EAST WHITELAND TOWNSHIP – ACT 537 PLAN DOCUMENTS
(SPECIAL STUDY 2011)

“SPECIAL STUDY”

RE: "Special Study" Act 537 Plan Amendment – Response to PADEP Comments
East Whiteland Township / Mill Lane Pumping Station Replacement Project

RE: Act 537 Special Study Amendment – Response #2
East Whiteland Township, Chester County
Mill Lane Pump Station Replacement Project

537 Data - 14.527 MGD, $n=0.013$
No Surge - All Flow Contained in Pipe

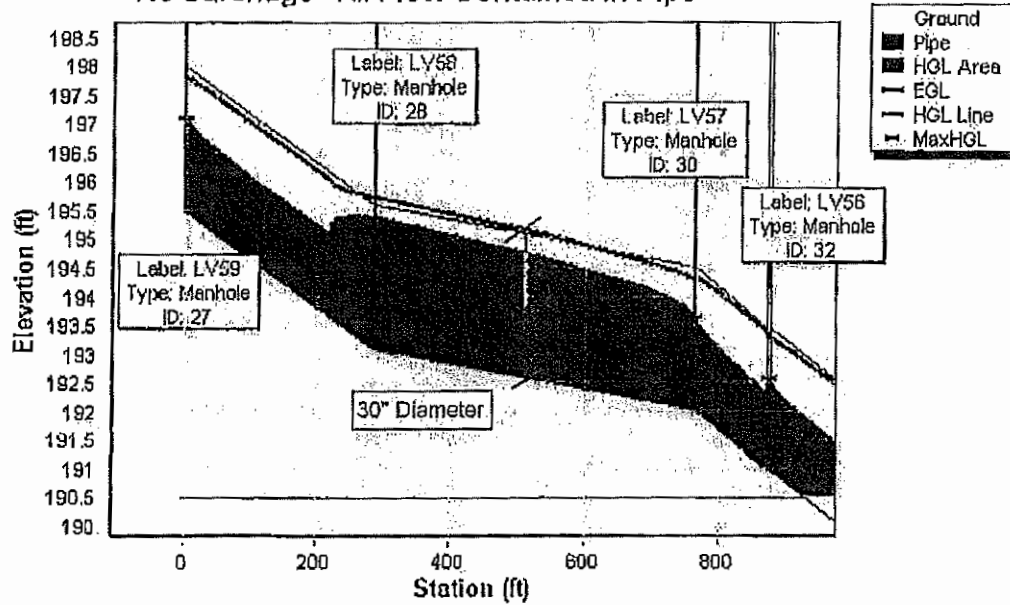
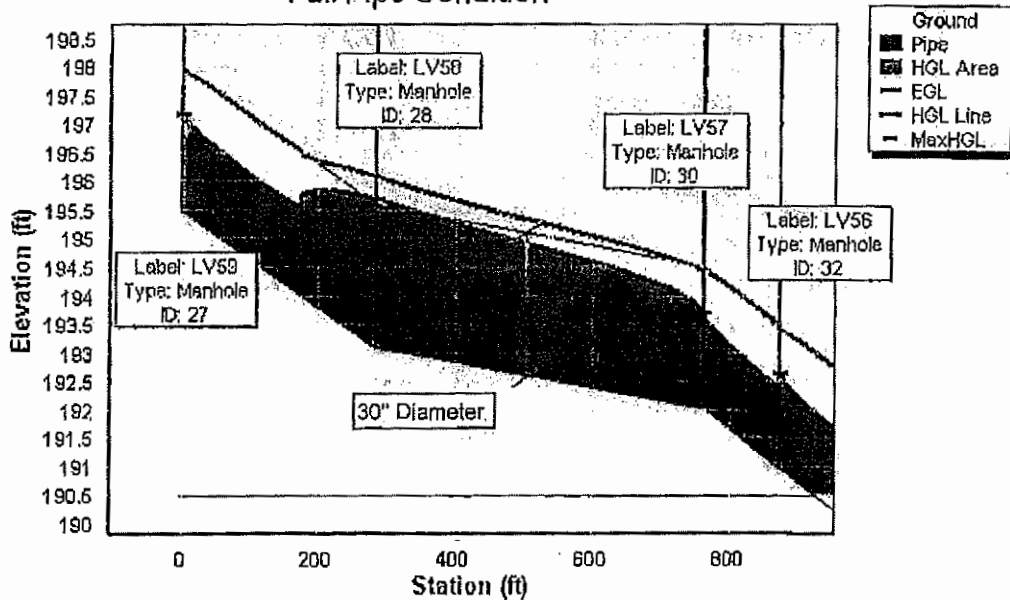
11. We note that the section of the Valley Creek Trunk Sewer (VCTS) from Manholes LV58 to LV57 is projected to exceed capacity from flows coming from the Township by 2018. Section 4.2.1 refers to a parallel sewer being proposed within the VCTS 537 Plan being prepared by Tredyffrin Township as a way to increase capacity within the section of the

12. Please clarify how the Township will manage connections and ensure that the sewage flow coming from the planned service area will not exceed the hydraulic capacity of the sewer section from MHLV 58 to MHLV57.

The proposed repair to section LV58 – LV57 of the Valley Creek Trunk Sewer has been deferred from the current VCTS 537 Plan due to a disagreement over who is responsible for paying for the repairs needed to restore the design capacity to this section of the trunk line. EWT asked that this section be removed from the current VCTS Plan so that the Plan can go through the approval process to allow other member municipalities to start capacity improvements that are needed now to protect public health and safety. EWT will continue to have dialogue with Tredyffrin Township and if necessary, will enter into arbitration in order to settle our argument over the assignment of cost for this pipeline repair.

Per EWT's Act 537 "Special Study" report; there are several areas of sewer improvements that are noted to be completed by the year 2015. Currently, the preliminary hydraulic analyses that have been completed are focused specifically on the infrastructure needs within EWT as they related to the future projected sanitary sewage flows. Prior to adding additional flow to the sanitary sewer network as part of these planned projects; EWT will participate in informational meetings with VCTS and Tredyffrin Twp to update them regarding the intent and to verify sewer capacities.

Note: LV58 Drawing invert of 193.10' was used for the model. All other inverts were adjusted based on slopes and lengths indicated in the October 2010 Act 537 Plan Revision. Ground elevation (top of manhole) at LV58 = 202.55' (therefore LV58 depth is 9.45').
